Pentium® Pro Processor Specification Update

Release Date: November 1998

Order Number: 242689-033

Figure 4-3. Stack Switch on a Call to a Different Privilege Level

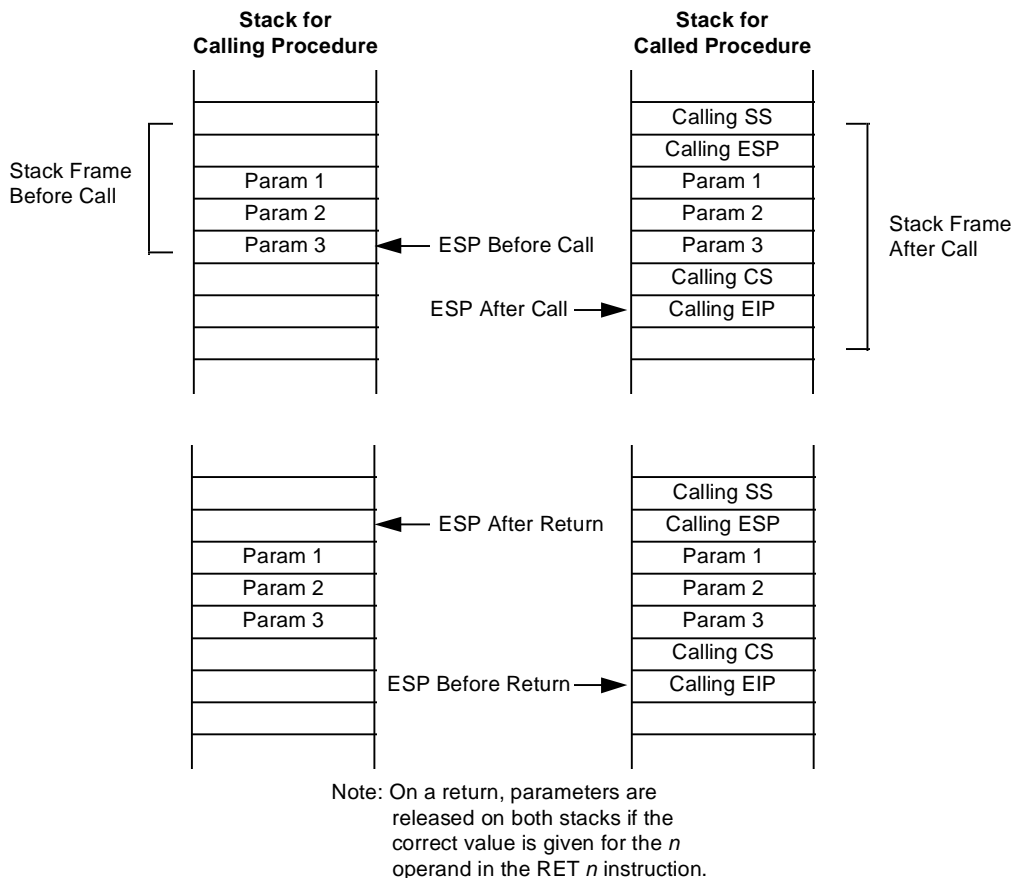
When making a call to a more privileged protection level, the processor does the following (see Figure 4-3):

Figure 4-4. Stack Usage on Transfers to Interrupt and Exception Handling Routines

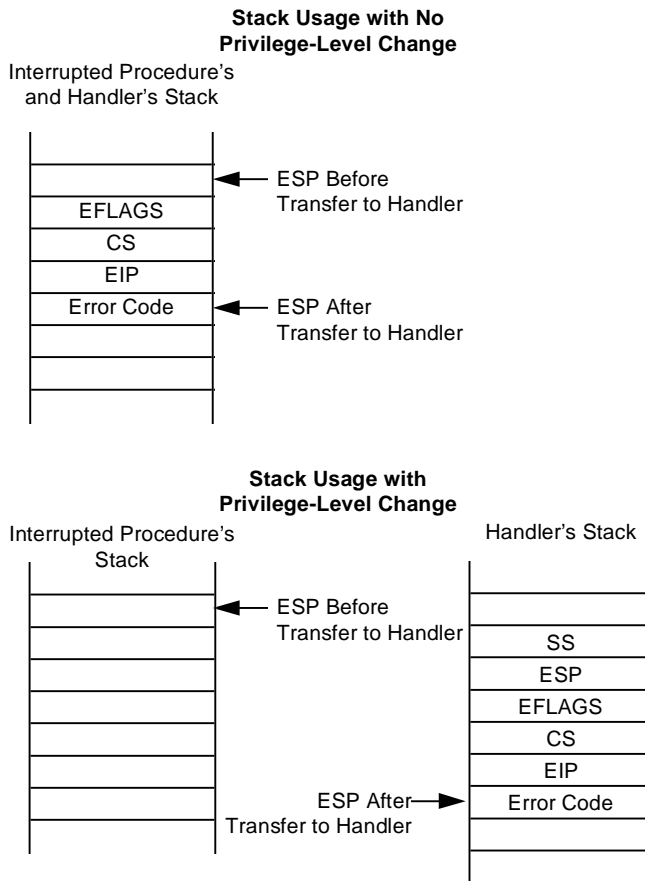
If no stack switch occurs, the processor does the following when calling an interrupt or exception handler (see Figure 44):
